UNITED STATES PATENT AND TRADEMARK OFFICE

Office Action Summary

10/758,559

KULICK, FRANK M.

FIG. 5

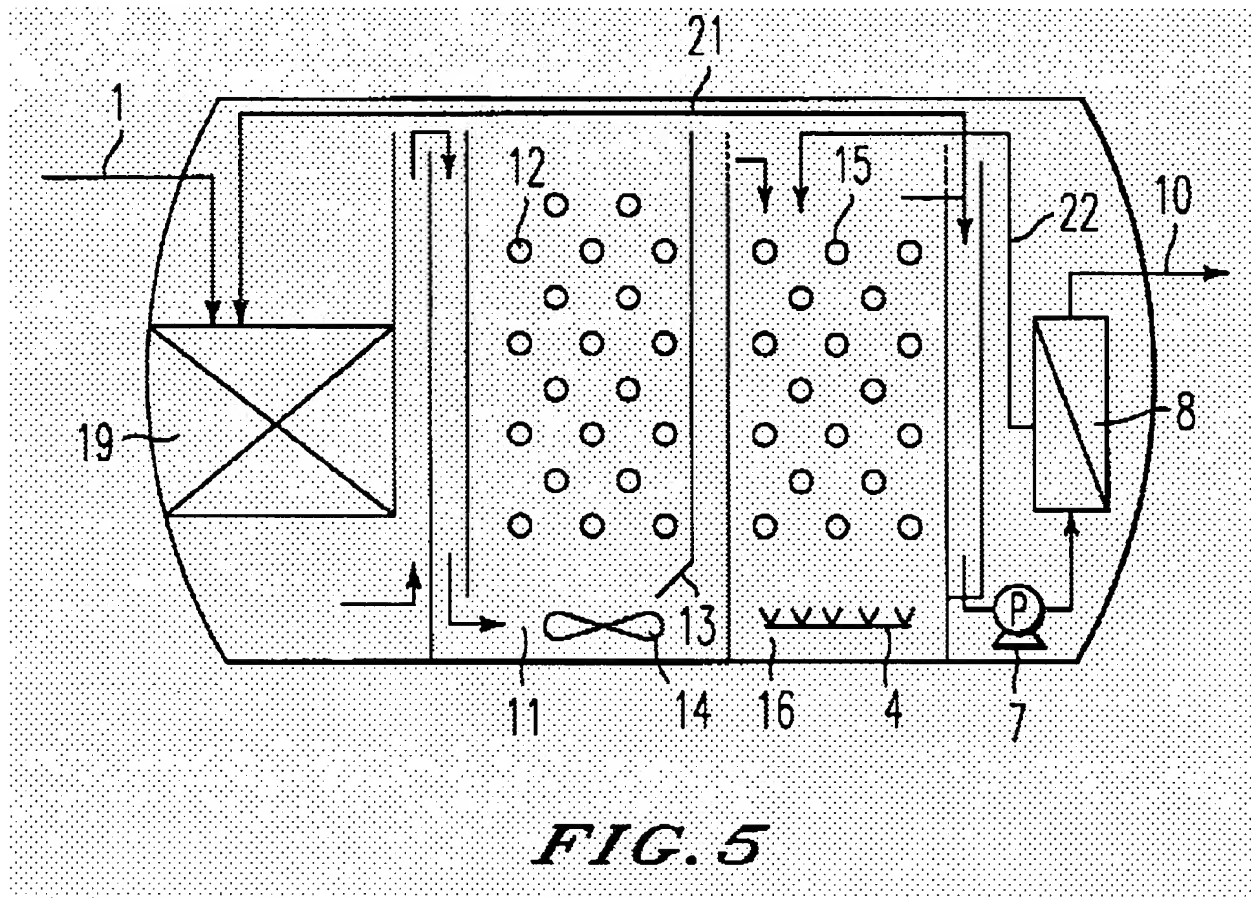
Claim 16 is rejected under 35 USC Sec. 103(a) as obvious over Tanaka. USP 6007712 describes a method of processing contaminated water 1 delivered to a

tank (shown above). The tank is internally divided by a plurality of baffles or weirs. The volumes of first precipitation tank portion 19, denitrification tank 11, and nitrification tank 16 are known, i.e., 0.5 m^3 , 0.2 m^3 , and 0.2 m^3 , respectively, but the volume of the compartment in which membrane filter 8 is located is not disclosed. The reference teaches, however, that a small setting area or "footprint," is desired (col 8 line 55). The reference also teaches that the membrane filter is made of 2 mm ID hollow fibers and 10 m^2 filtration area (col 17 line 67; col 16 line 55). Hollow fibers are generally of a cylindrical shape. Insofar as a small tank footprint is desired, the skilled artisan would

have been motivated to arrange the membrane filter vertically within the outer compartment of the nitrification tank (as shown above). The resulting volume of the compactly-arranged membrane filter-housing compartment would have been smaller than at least the nitrification tank into which the retained solids portion (retentate) from the membrane-filter is returned via 22. In other words, biosolids are recycled back to the larger nitrification tank from the membrane filter. Clarified filtrate is discharged from the vessel via 10.
